**MEMORANDUM
OFFICE OF THE STATE ENGINEER
HYDROLOGY BUREAU**

DATE: November 15, 2022
TO: David Otori, Permit Lead, Mining Act Reclamation Program (MARF)/MMD
Holland Shepherd, Program Manager, MARF/MMD
THROUGH: Katie Zemlick, Ph.D., Chief, Hydrology Bureau *KZ*
Laura Petronis, Water Resources Manager 1, Hydrology Bureau *LJP*
FROM: Brad Wolaver, Ph.D., Senior Hydrologist, Hydrology Bureau *BDW*
Christopher E. Angel, P.G., Senior Hydrologist, Hydrology Bureau *CEA*
SUBJECT: Review and Comments, Revision 22-1 to Mt. Taylor Mine, Permit No. CI002RE,
Rio Grande Resources Corporation

**Appendix A. Mine Shaft Proposed Design with Pump Stations and Stratigraphy
(Drawing No. 1000-03)**

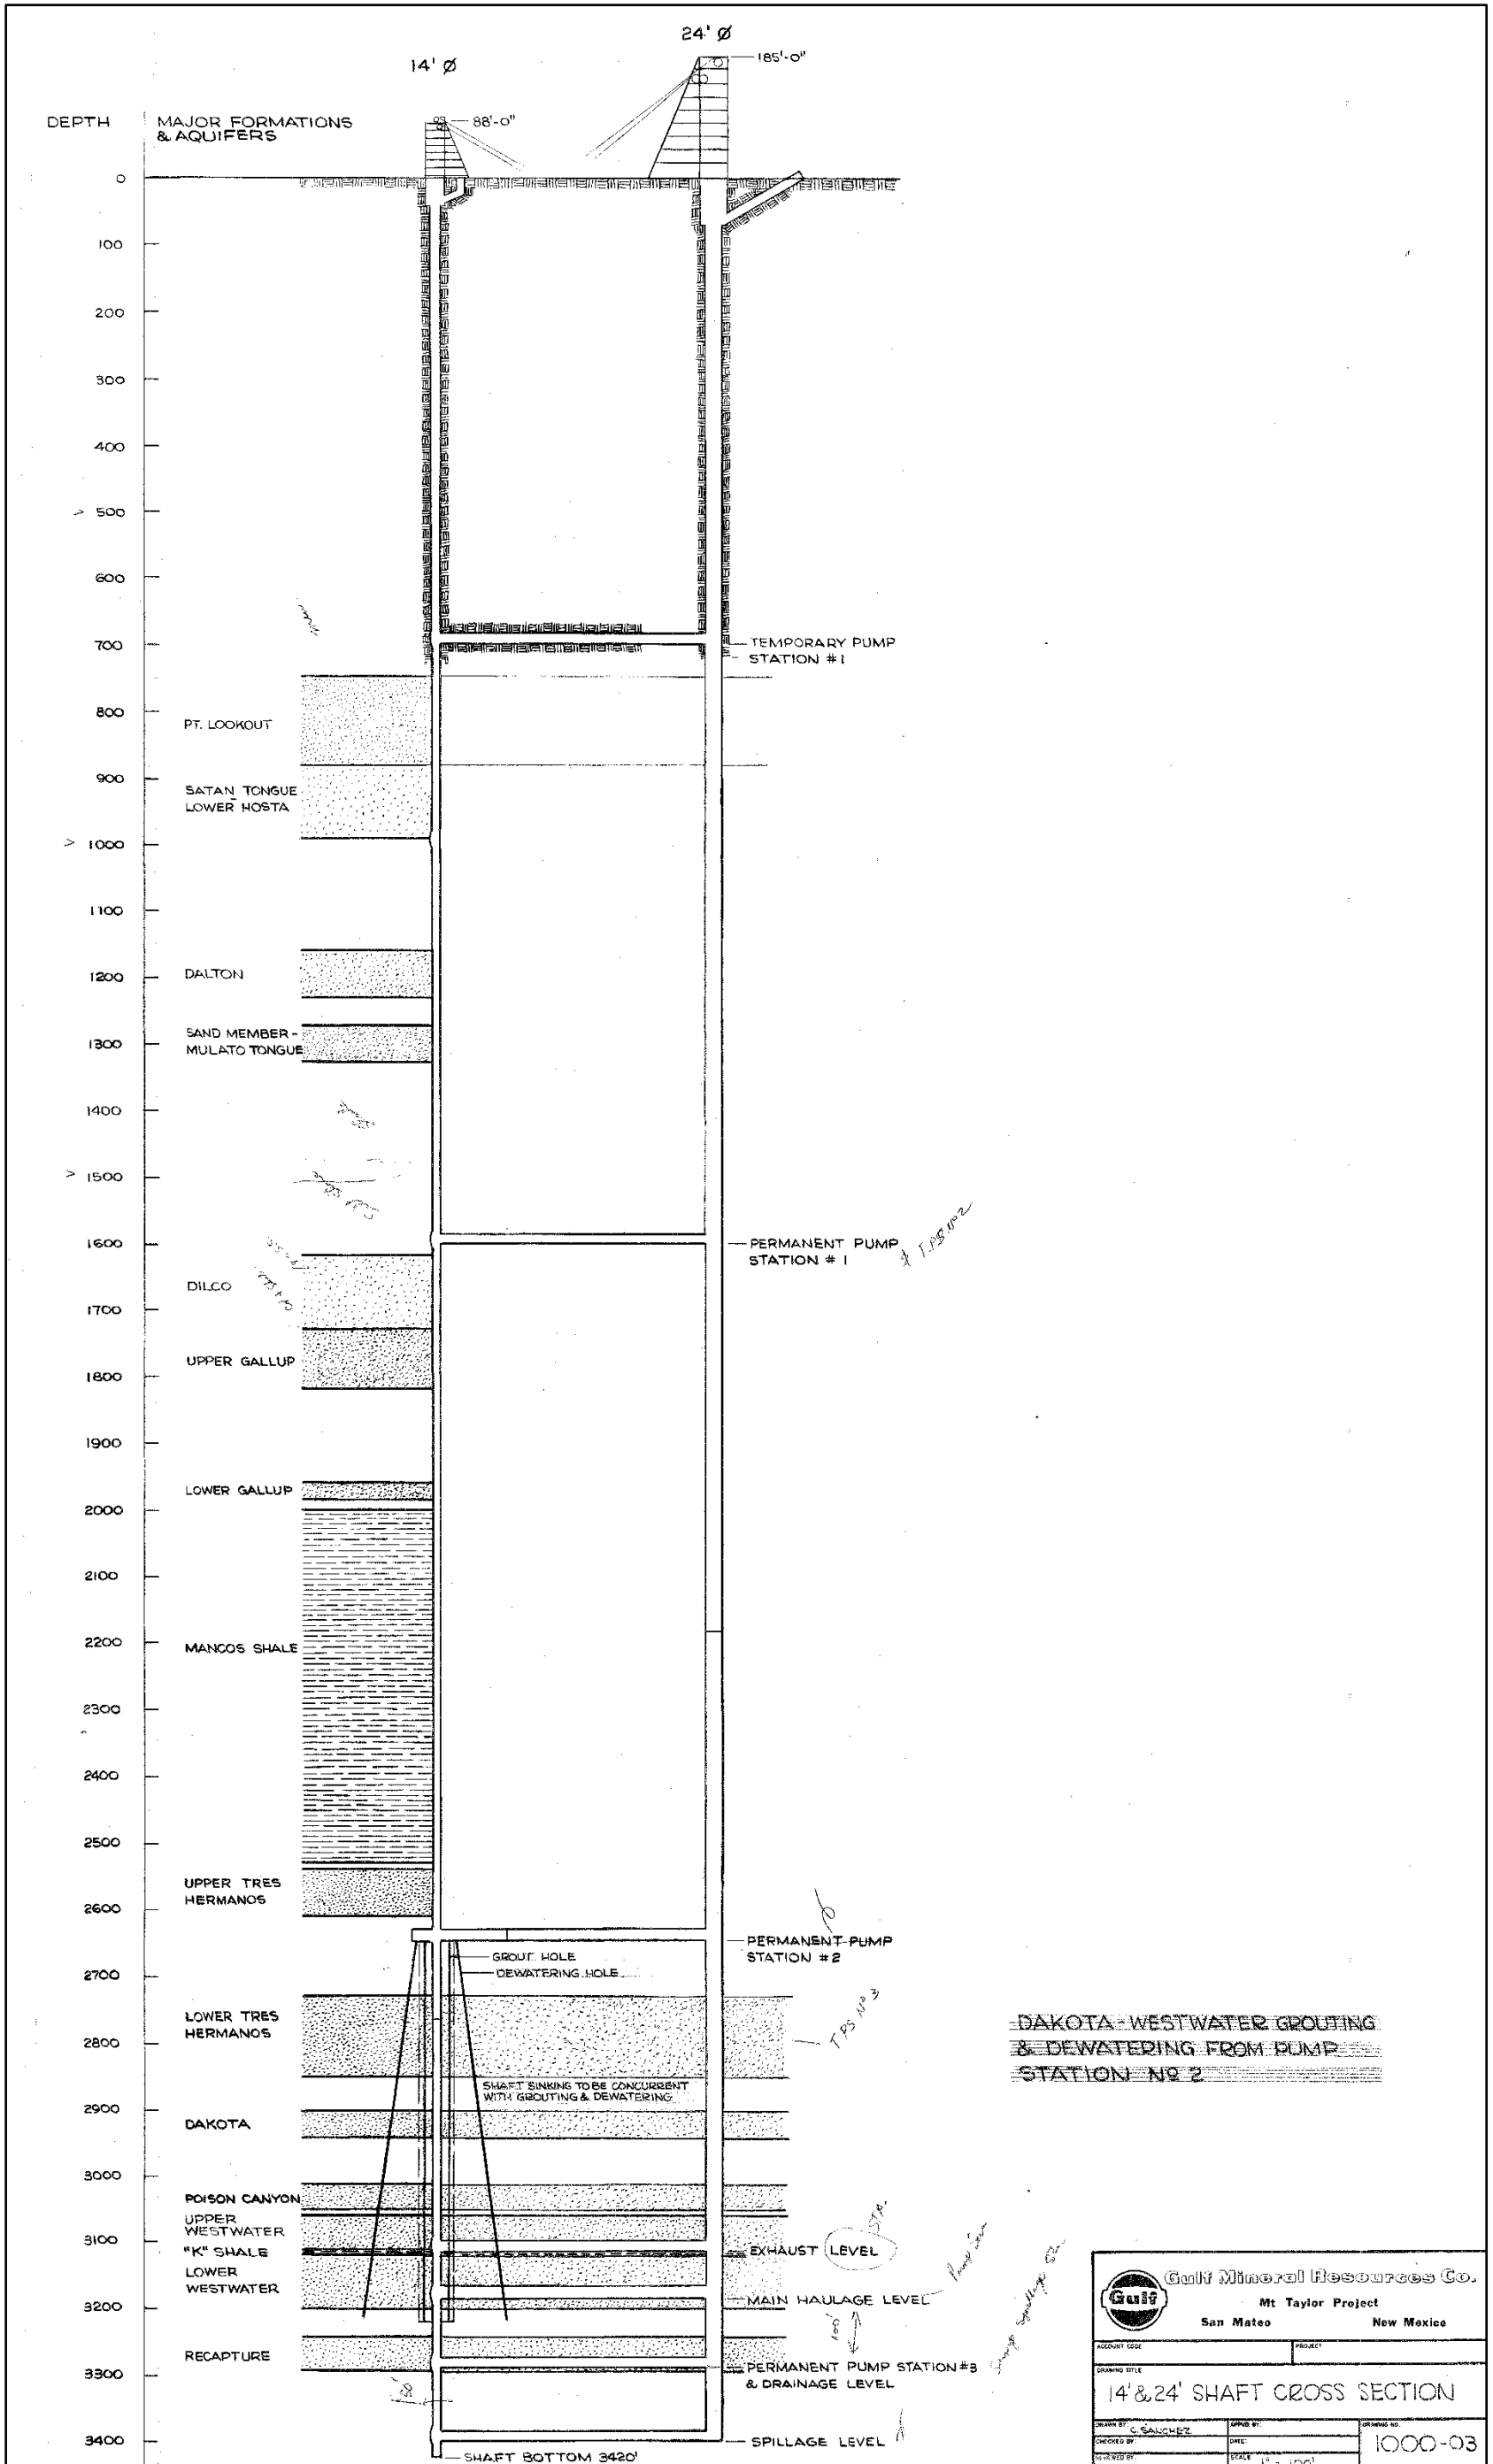
Prior to shaft construction, a grout design with permeability of 10^{-9} cm/s was proposed (i.e., Celcite 55 Terraseal; **Appendix A**). However, as-built documentation was not provided by RGR describing if this grout was injected into the formation. A 1977 report on grouting of the Dakota (**Appendix B**) indicates that grouting had already taken place in the Menefee and Point Lookout; however, the report does not specify as-built materials used for the grouting these intervals. The

report also reports Dakota fractures up to 3.5-in wide and a seventy-foot head decline from 1972 to 1977, which appears to be from the dewatering program. The report discusses testing to be performed to determine the effectiveness of the grout, but RGR has not provided information regarding any grout effectiveness testing.

Appendix C. Proposed Shaft Lining Design (Drawing No. 615-C08-616)

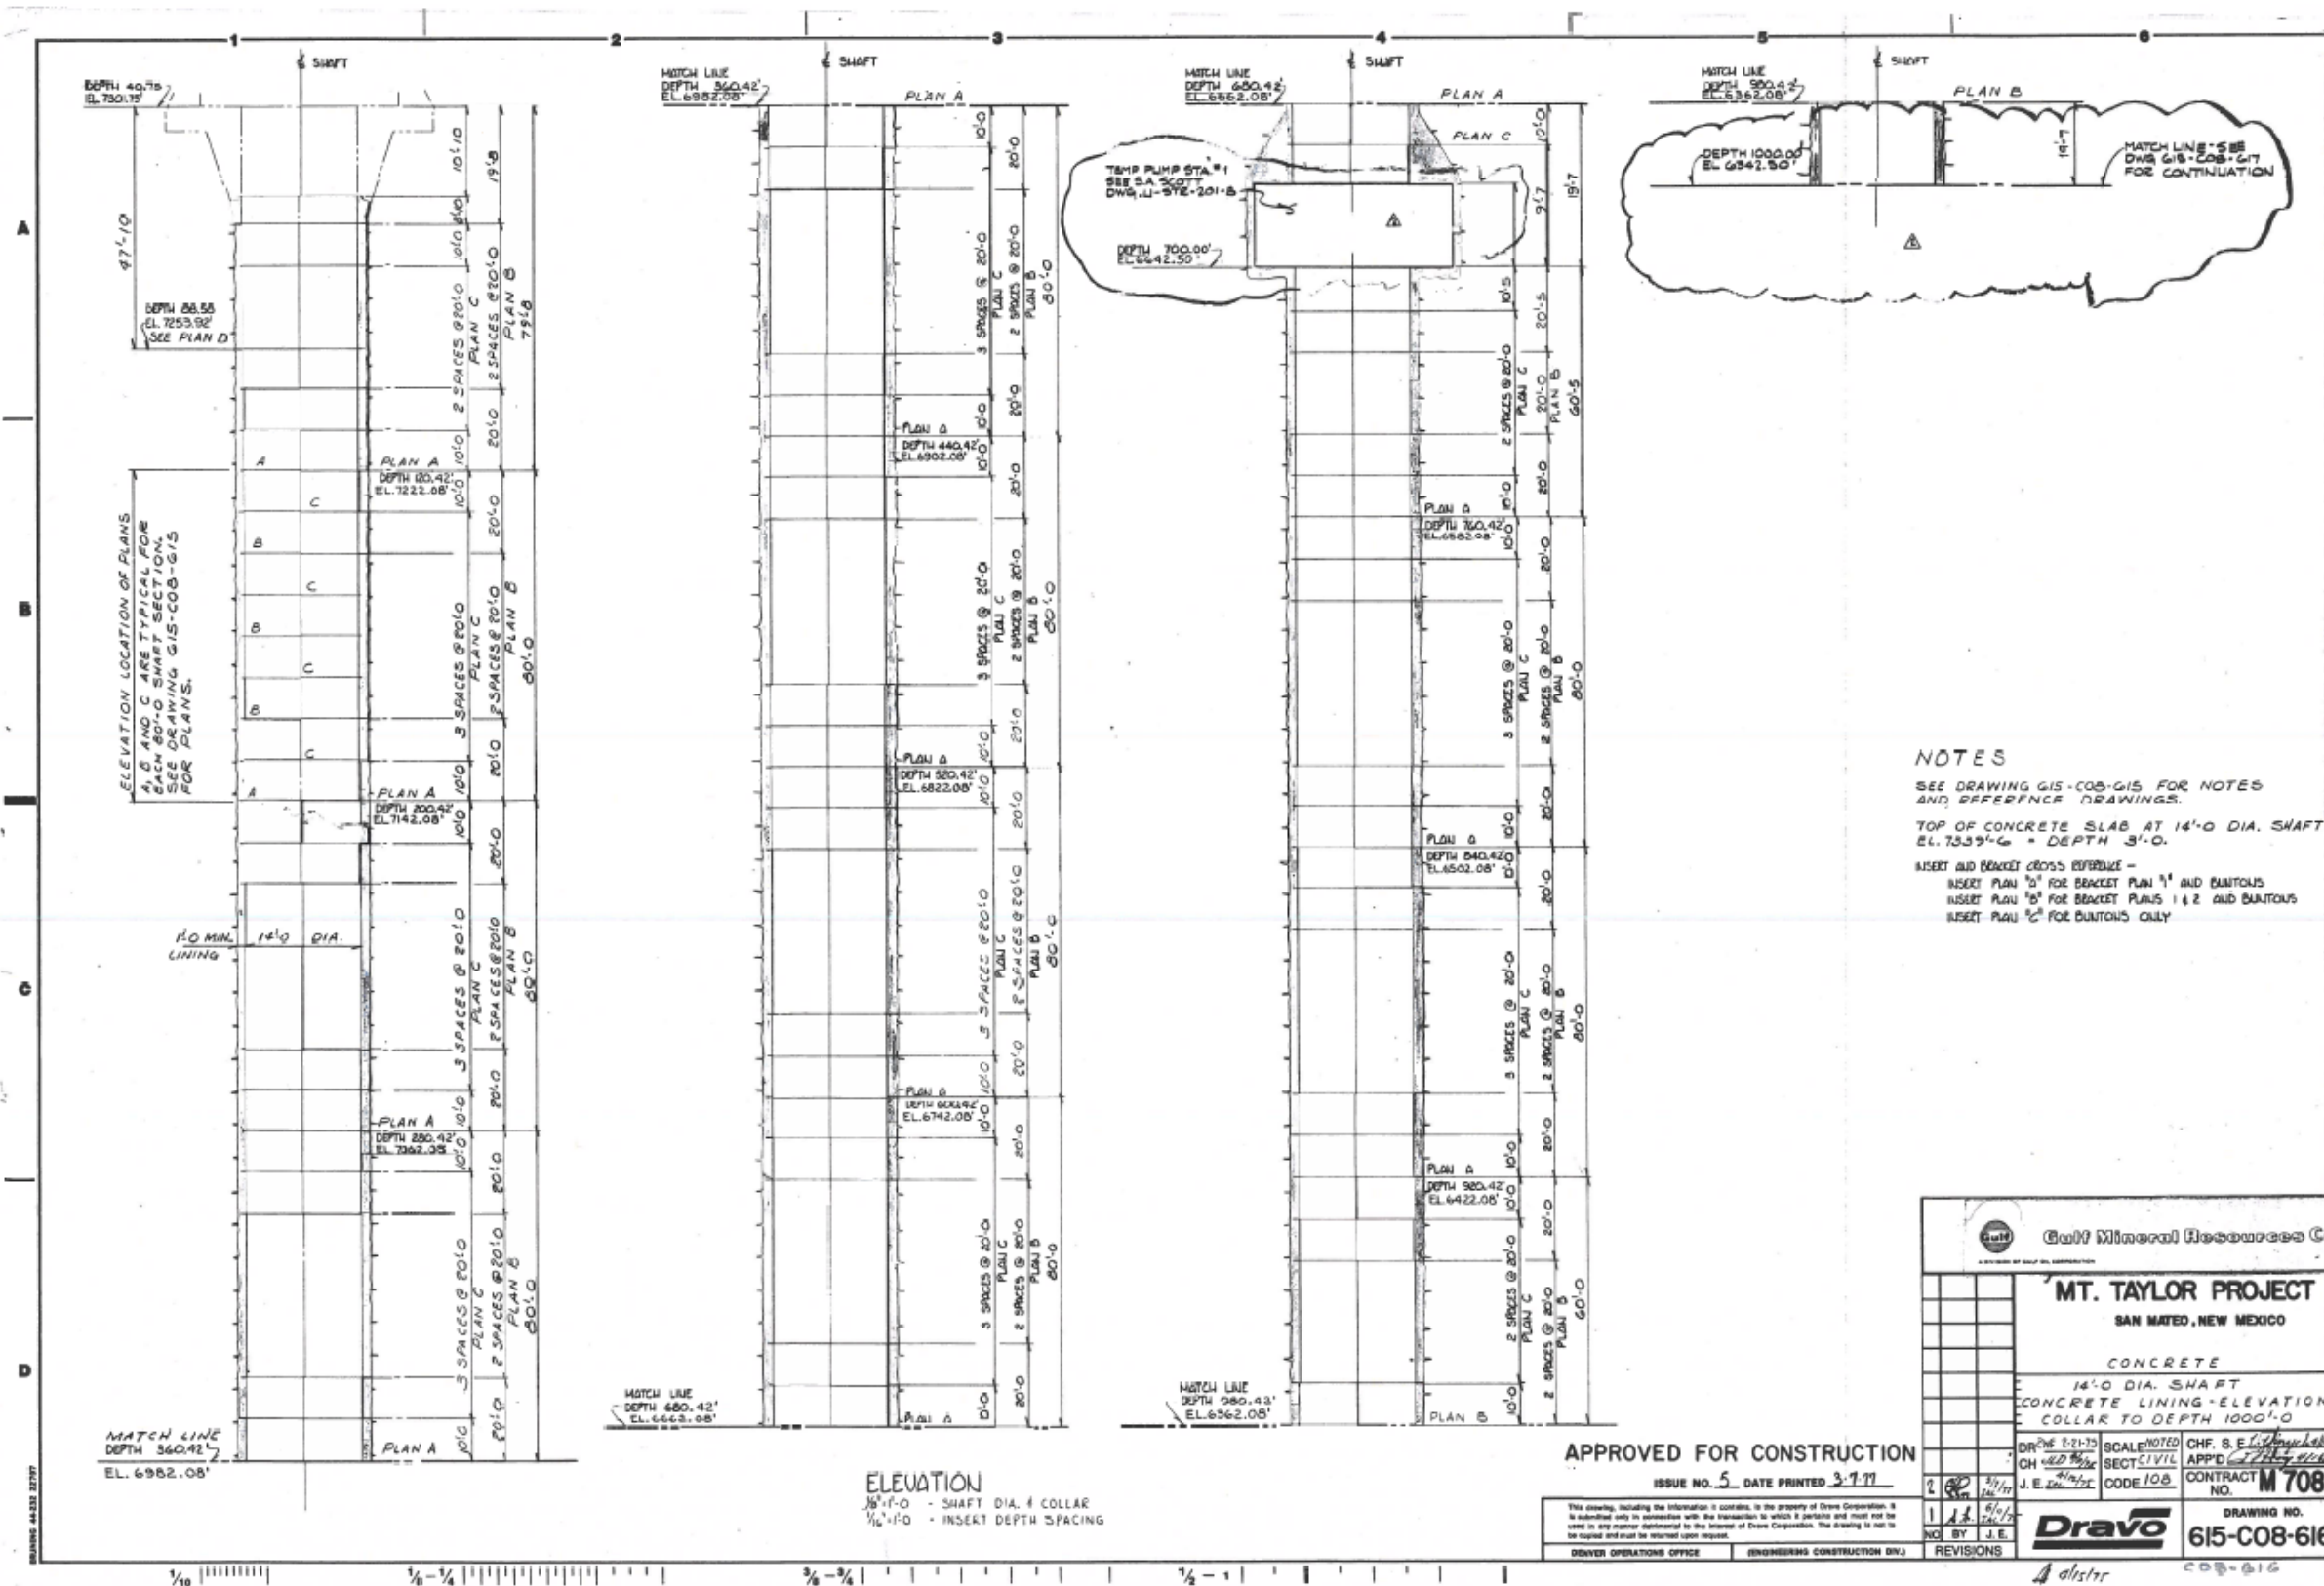
The shafts are lined with cast-in-place concrete liners to isolate the shafts from aquifers and prevent inter-aquifer communication (**Appendix C**). RGR provided NMOSE with concrete specifications for the shaft lining that indicates the cement to sand and rock ratio was approximately twenty percent cement (i.e., 610 lbs cement, 1323 lbs sand, 1643 lbs rock; **Appendix D**). The water-cement ratio of the design is approximately fifty percent. RGR has not specified what as-built Type of cement was used (e.g., ASTM Type I, Type II, etc.). The Type cement may be important based on the concentration of sulfate in groundwater. According to the Bureau of Reclamation Concrete Manual, “hardened concrete is inherently somewhat pervious [i.e., permeable] to water which may enter through capillary pores or forced in by pressure” (BOR 1988) (**Appendix D**). Thus, groundwater would be forced through the concrete by hydrostatic pressure. Also, concrete permeability increases steadily when the water-cement ratio exceeds fifty-five percent by weight and with increase in aggregate size (BOR 1988) (**Appendix E**). In addition, tensile strength seldom exceeds ten percent of the compressive strength (BOR 1988). Thus, a lack of compressive strength allows for the concrete to crack and flake apart. The stressor of water pushing through the concrete may also increase the deterioration. To understand the shafts better and characterize leakage potential, Hydrology requests: 1) Results of grout curtain effectiveness testing (if conducted; **Appendix B**), 2) Results of tests evaluating the sulfate-resistance of cement (if conducted; **Appendix B**), and 3) an explanation of shaft liner spacers and what type of joint between shaft sections was used (**Appendix C**). Hydrology is concerned about the permeability of shaft liner concrete. Results of permeability tests, if conducted, would be useful to evaluate concrete degradation and leakage potential.

- An explanation of what type of joint was used to construct the shaft liners to understand the potential for groundwater inflows through shaft liner joints,
